TOWN OF TIBURON  
1505 Tiburon Boulevard  
Tiburon, CA 94920

Design Review Board Meeting  
December 15, 2011  
Agenda Item: **I**

## STAFF REPORT

**Subject:** 8 Wilkins Court; File #21117  
Adoption of a Resolution Denying Site Plan and Architectural Review for the Construction of Deck Additions to an Existing Single-Family Dwelling, with a Variance for Reduced Side Yard Setback  
(Continued from December 1, 2011)

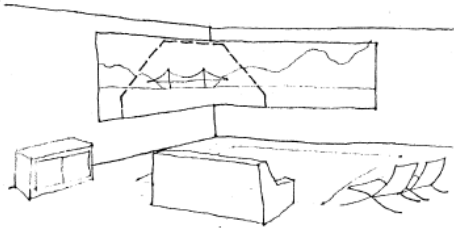
- *Goal 3, Principle 7(a) states the view protection is more important for the primary living areas of a dwelling (i.e. living, dining, family, great room, kitchen and decks associated with these rooms) than less actively used areas of a dwelling (i.e. bedroom, bathroom, study, office, den).*

• PROPOSED STRUCTURE  
BLOCKS LIVING ROOM VIEW -

• GREAT IMPACT ON  
LIVABILITY

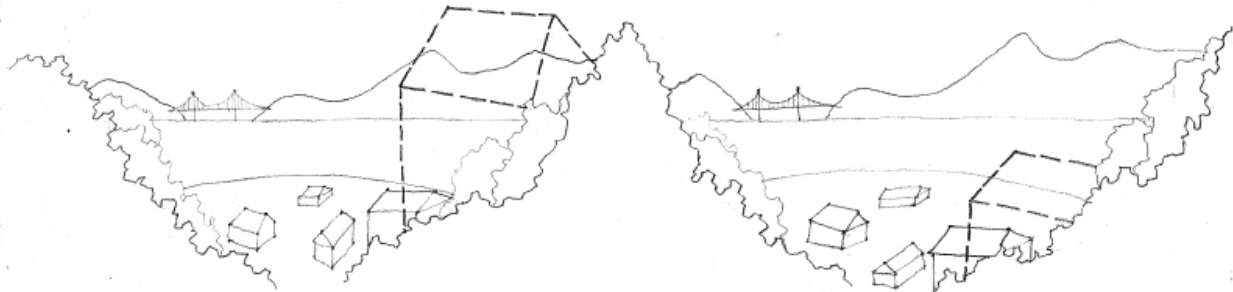
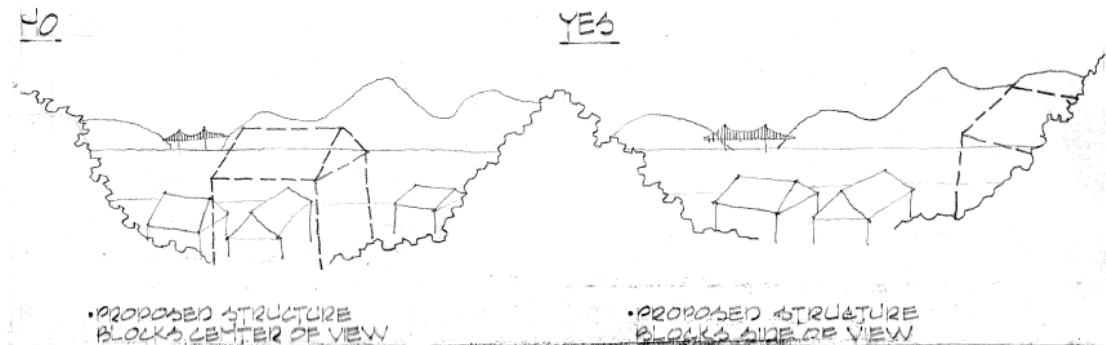
- *Goal 3, Principle 7(b) states that the horizon line is the most sensitive part of a view, then foreground, then middleground. If possible, avoid cutting the horizon line of a neighbor's view.*

The proposed dwelling would impact the left portion of the foreground and middleground of the view from the kitchen window at 89 Sugar Loaf Drive.

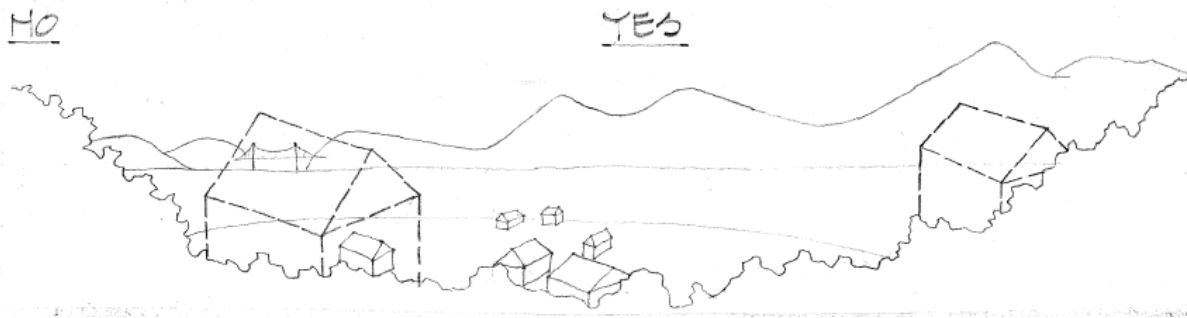
- Goal 3, Principle 7(c) states that blockage of the center of a view is more damaging than blockage of a side view.

The proposed dwelling would block the side view of Richardson Bay from the kitchen window at 89 Sugar Loaf Drive.
